Attention: Docket ID EPA-HQ-OAR-2023-0434

RE: Waste Emissions Charge for Petroleum and Natural Gas Systems

The American Petroleum Institute, American Exploration and Production Council, American Fuel and Petrochemical Manufacturers, Independent Petroleum Association of America, LNG Allies - The USLNG Association, Energy Workforce and Technology Council, Western States Petroleum Association, Alaska Oil and Gas Association, Kentucky Oil and Gas Association, Louisiana Mid-Continent Oil and Gas Association, Michigan Oil and Gas Association, New Mexico Oil and Gas Association, North Dakota Petroleum Council, Ohio Oil and Gas Association, The Petroleum Alliance of Oklahoma, Pennsylvania Independent Oil and Gas Association, Texas Independent Producers and Royalty Owners Association, Utah Petroleum Association, Gas and Oil Association of West Virginia, and Petroleum Association of Wyoming (collectively, the "Industry Trades") respectfully submit the below comments on the Environmental Protection Agency's (EPA) Proposed Rule "Waste Emissions Charge for Petroleum and Natural Gas Systems" (89 FR 5318, January 26, 2024) ("WEC").

Figure 1. Multi-layered Approach for Leak Detection

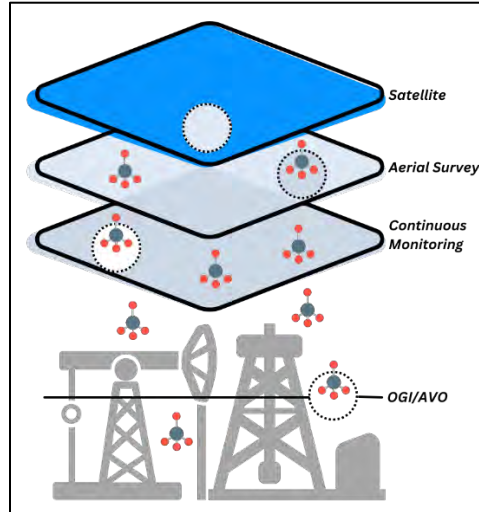
EPA has already included the idea of layering technologies with the screening survey plus annual OGI survey options in the periodic screening matrices. API has two specific suggestions regarding an alternative multi-layered approach for leak detection:

Figure 2. Flowchart of Proposed Follow-up Actions for Periodic Screening Surveys

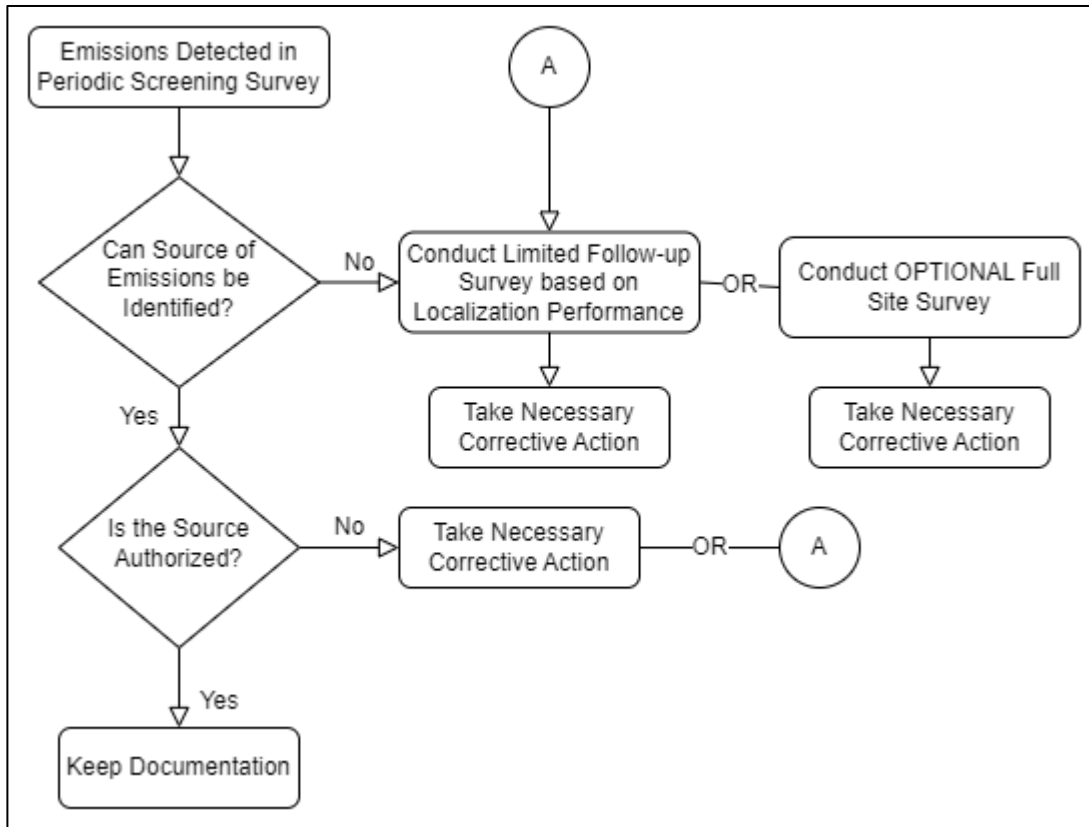
alternative technology and/or other data. Alternative technology has varying degrees of localization performance in terms of being able to identify emissions on the site-level, equipment group-level, equipment-level, or component-level. Our proposed follow-up action process gives operators the necessary flexibility in responding to detected emissions and is presented in Figure 2 and described in detail below.

When emissions are detected in a periodic screening survey, the operator first tries to identify the source of emissions from the survey results and other available information. For safety and cost reasons, follow-up surveys in the field should be limited to situations where additional information is needed to identify or confirm the source of detected emissions. If the source of detected emissions can be identified, next steps would be based on the type of source.

- **EPA should also clarify that limited or full site follow-up OGI surveys should be allowed in response to emissions detected by continuous monitoring depending on the localization performance of the continuous monitor(s).** A limited or full site follow-up OGI survey may be a useful tool in identifying the source of emissions and therefore appropriate corrective actions. API recommends that the proposed follow-up action process for periodic screening surveys based on localization performance also apply to continuous / near continuous monitoring; refer to Comment 3.3.2 and Figure 2 for more details.

Figure 1. Multi-layered Approach for Leak Detection

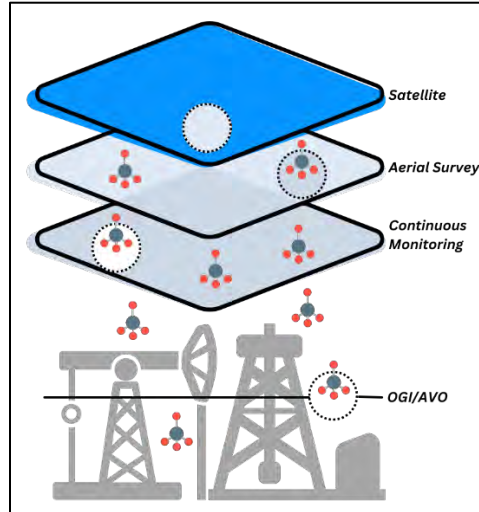
EPA has already included the idea of layering technologies with the screening survey plus annual OGI survey options in the periodic screening matrices. API has two specific suggestions regarding an alternative multi-layered approach for leak detection:

Figure 2. Flowchart of Proposed Follow-up Actions for Periodic Screening Surveys

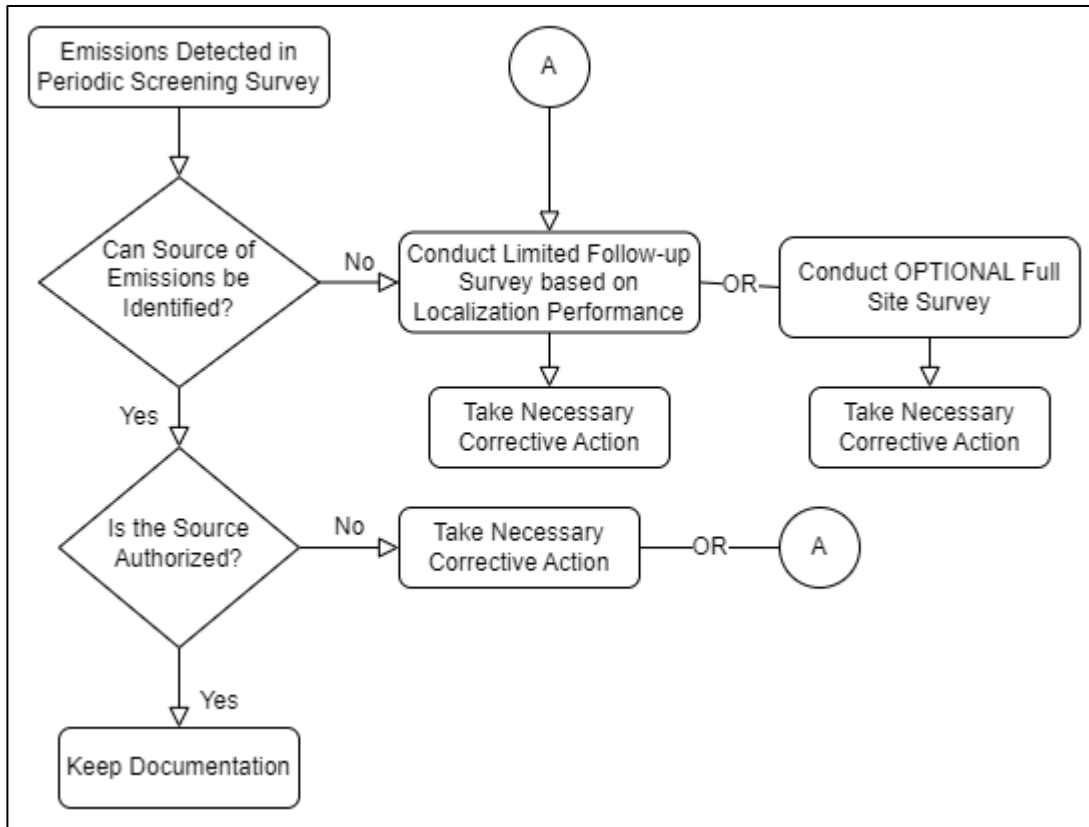
alternative technology and/or other data. Alternative technology has varying degrees of localization performance in terms of being able to identify emissions on the site-level, equipment group-level, equipment-level, or component-level. Our proposed follow-up action process gives operators the necessary flexibility in responding to detected emissions and is presented in Figure 2 and described in detail below.

When emissions are detected in a periodic screening survey, the operator first tries to identify the source of emissions from the survey results and other available information. For safety and cost reasons, follow-up surveys in the field should be limited to situations where additional information is needed to identify or confirm the source of detected emissions. If the source of detected emissions can be identified, next steps would be based on the type of source.

- **EPA should also clarify that limited or full site follow-up OGI surveys should be allowed in response to emissions detected by continuous monitoring depending on the localization performance of the continuous monitor(s).** A limited or full site follow-up OGI survey may be a useful tool in identifying the source of emissions and therefore appropriate corrective actions. API recommends that the proposed follow-up action process for periodic screening surveys based on localization performance also apply to continuous / near continuous monitoring; refer to Comment 3.3.2 and Figure 2 for more details.
